From: Brian Smith
To: internet:cpadtech.com:almc
Date: 8/26/96 12:25pm
Subject: IMS Deficiency Letter

UNITED STATES
NUCLEAR REGULATORY COMMISSION

This concerns information about an Ion Mobility Spectrometer (IMS) Detector which was submitted with your letter received July 10, 1996, and your subsequent conversation with Ms. Kathleen Dolce of Region I. We are in the process of reviewing the information and have identified areas where additional information or clarification is needed. As requested in your conversation with Ms. Dolce, the information was reviewed for distribution of the devices under an exempt distribution license under 10 CFR 32.26. As per 10 CFR 32.26, these devices will be used by persons defined in 10 CFR 30.20. It is our understanding that a letter will be submitted explaining this change. Because 10 CFR 32.26 contains different requirements than 10 CFR 32.51, which your original submittal requested the devices to be distributed under, additional information will be necessary and some changes will be required to be made to the information originally submitted.

In order to complete our review, please provide the following:

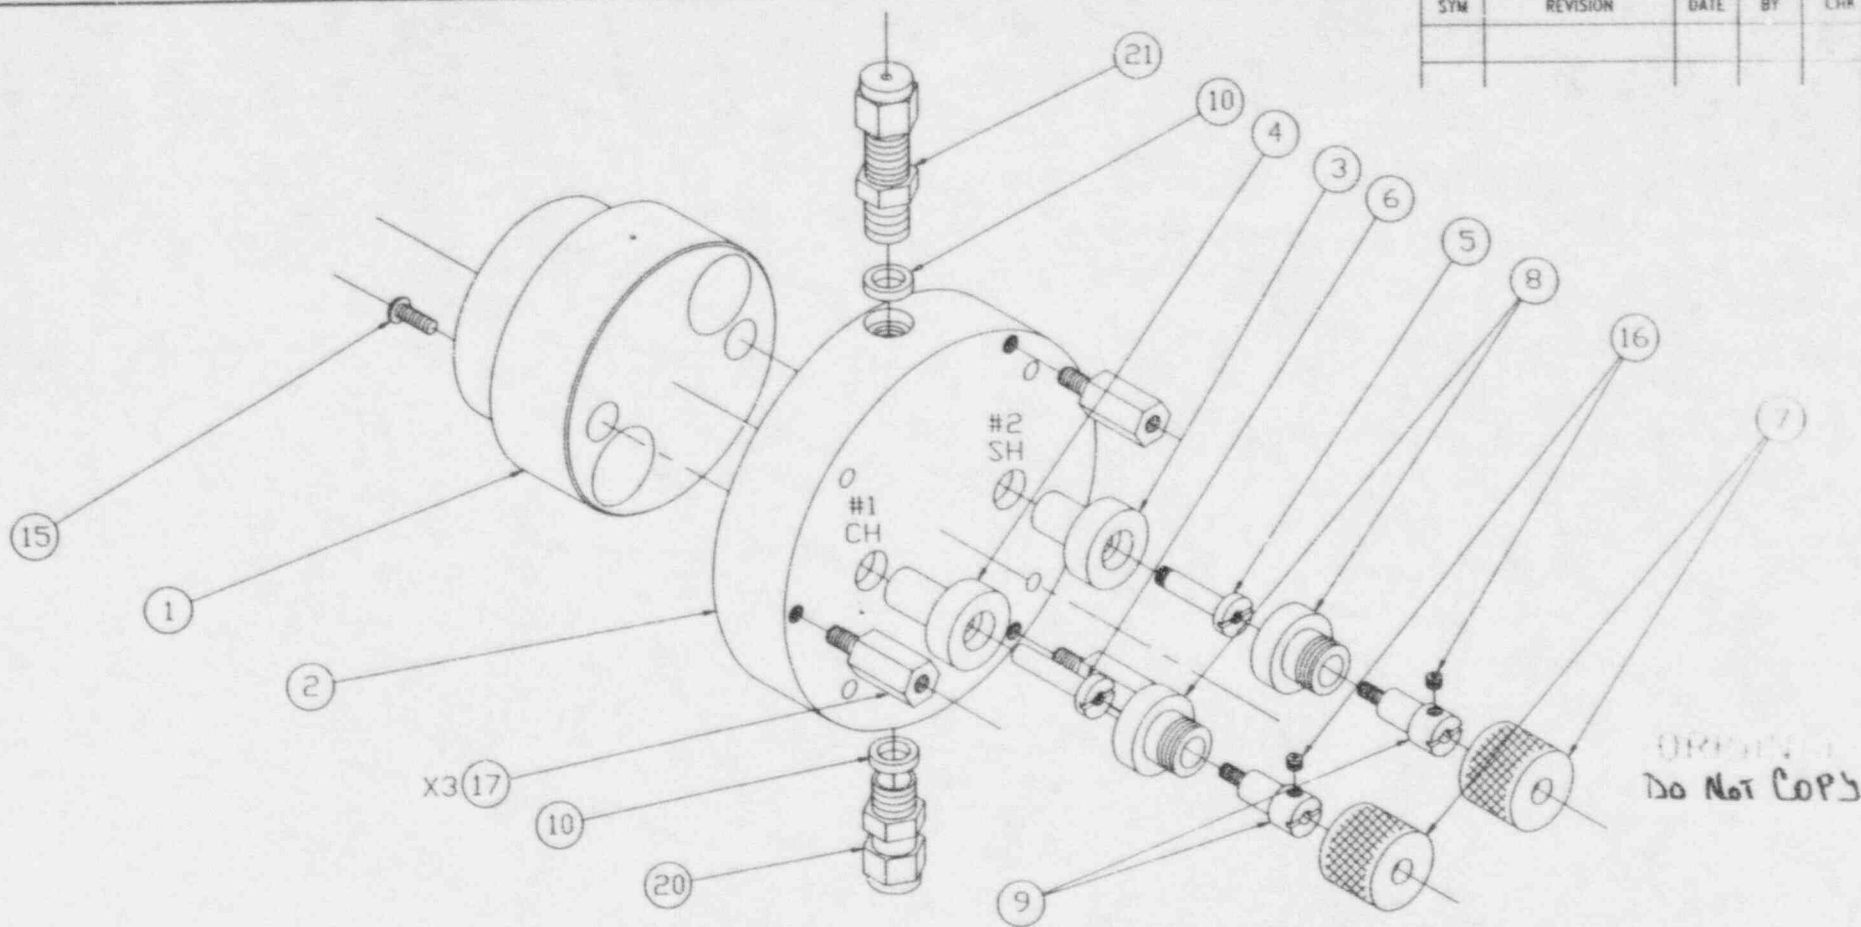
*takes out + resubmit
or
propose them*

LA-B-007

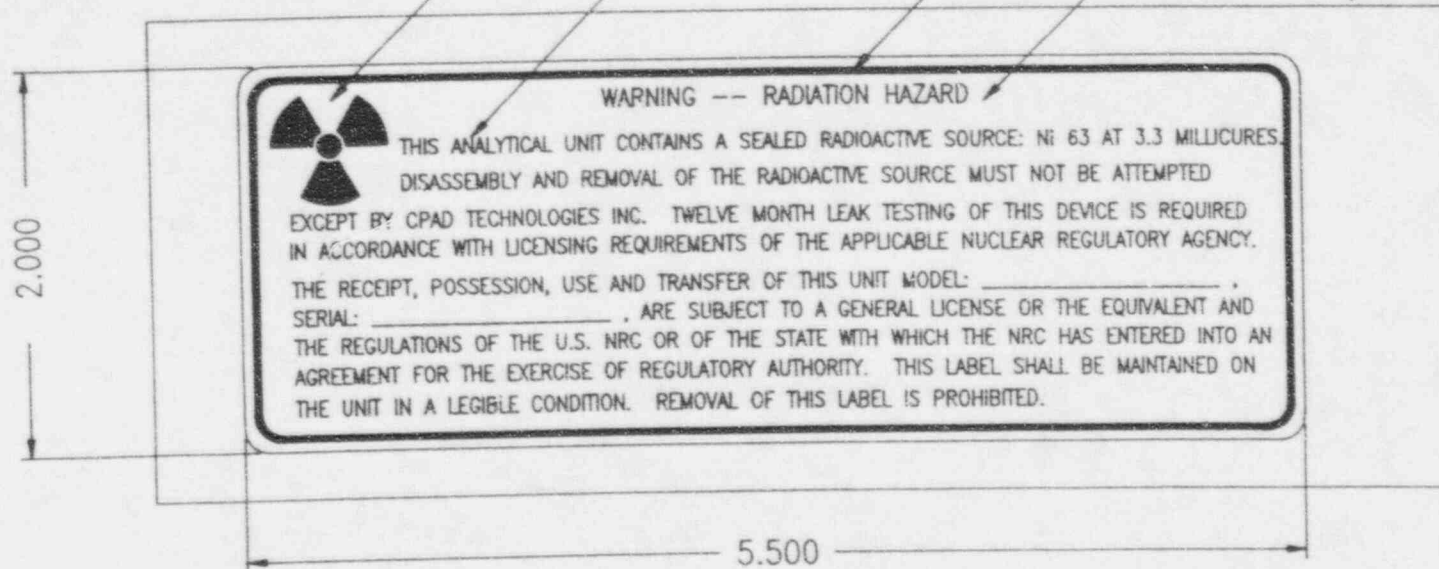
- A label must be placed on the detector that contains the following: (1) the words "Contains Radioactive Material," (2) the name of the radionuclide and quantity of activity, and (3) the identity of the 10 CFR 32.26 licensee. The label must be durable, legible, and readily visible when the detector is removed from the analytical unit (box that contains the IMS detector). Please provide the wording or samples of the label to be placed on the detector.

- These labels need to be permanently affixed to the device and made of a material that will retain its integrity during use. Please indicate the materials of construction of the labels. In addition, please provide information on the label adhesive, such as solubility, effective temperature range, etc.
